**Proposal #29: 1517-75-73, WISC 2018 157
 USH 10 – USH 10/STH 441
 County CB – Oneida Street
 USH 10
 Winnebago County**

Letting of March 13, 2018

This is Addendum No. 02, which provides for the following:

Addendum No. 02
ID 1517-75-73
Revised Sheet 84
March 5, 2018

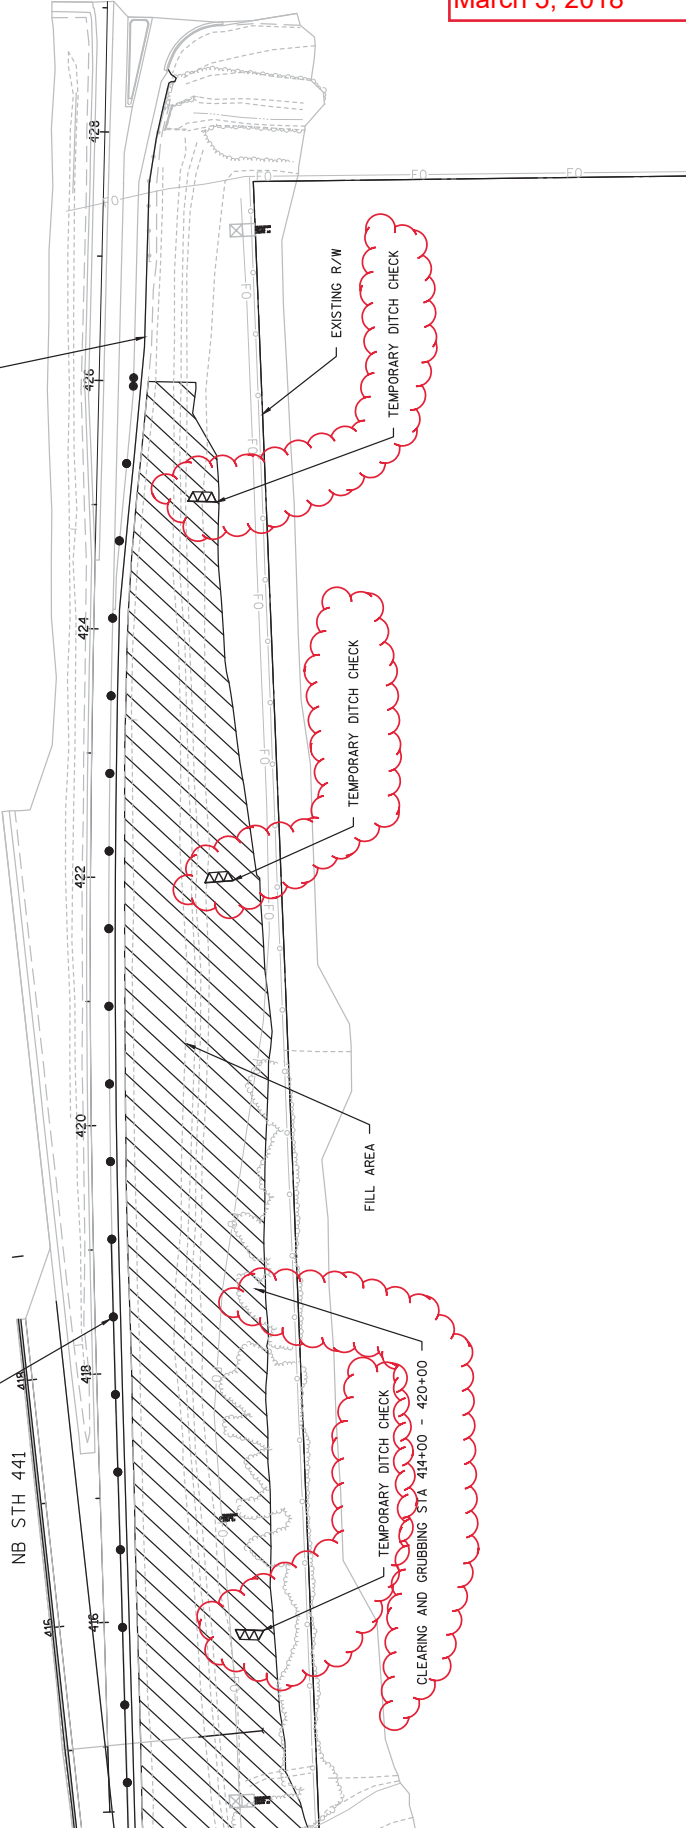
Revised Plan Sheets	
Plan Sheet	Plan Sheet Title (brief description of changes to sheet)
84 & 85	1517-75-73 Construction Detail at Fill Site adding Sign work and erosion control
319-323	1517-75-73 Permanent Signing w/ Speed Limit Sign Revisions
823	1517-75-73 Clearing and Grubbing table to add work at Fill site

Addendum No. 02
ID 1517-75-73
Revised Sheet 1184
March 5, 2018

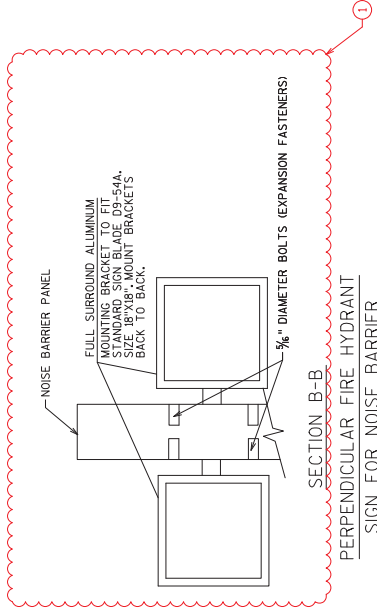
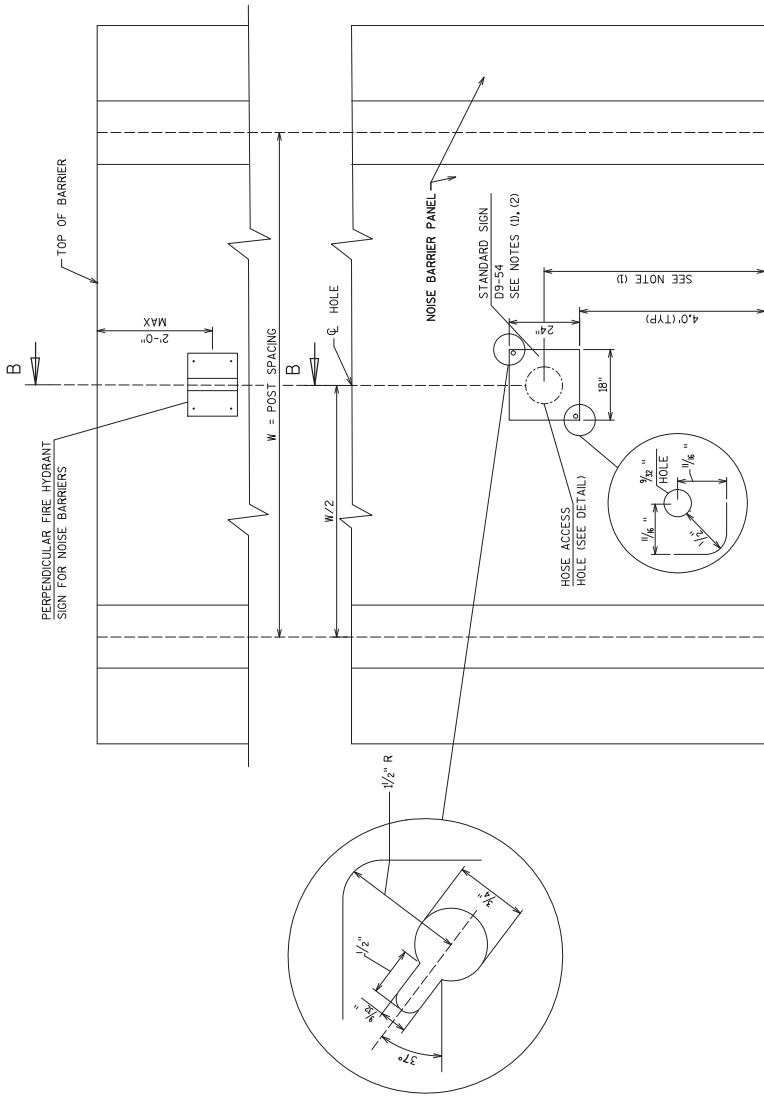
829	1517-75-73 Common Excavation quantity modification to account for clay liner excavation
841	1517-75-73 Apron Endwall MQ modified to remove duplicate endwall
867	1517-75-73 Erosion Control MQ modified for work at Fill Site
875-877	1517-75-73 Permanent signing MQ modified for work at Fill Site and for Speed limit change
1184	1517-75-73 Structures N-70-121, 130, 131, 140 – added correct bracket needed for Fire Hydrant and addresses to put on the sign

N-70-130: STA. 1H+66.00 (ADDRESS: 1665 UNIVERSITY DRIVE)
N-70-131: STA. 7H+60.00 (ADDRESS: MID ALCAN DRIVE) & STA. 17+37.00 (ADDRESS: 1699 ALCAN DRIVE)
N-70-140: STA. 1H+09.00 (ADDRESS: ITI ALCORN COURT)
NOTE: FIRE HOSE ACCESS HOLE LOCATIONS ARE APPROXIMATE; ADJUST LOCATION OF ACCESS HOLES AS NEEDED TO BE CENTERED ON THE AS-FABRICATED PANEL.
